Ford & International 6.9 Liter Diesel engines CARDONE Part 59-8304 & 59-8305

WATER PUMP MOUNTING BOLT LENGTHS & LOCATIONS

MS 6324 PT 58-0005

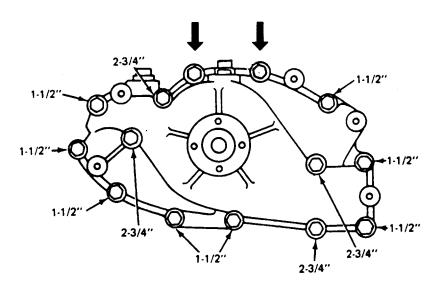
If the mounting flange on the original pump is 1-1/16" thick at the top two mounting holes and if the replacement unit is 13/16" thick, you must use two 1/8" spacers or 1-1/4" bolts.

IF THIS IS NOT DONE, INJECTOR PUMP FAILURE WILL OCCUR AND VOID THE WATER PUMP WARRANTY.
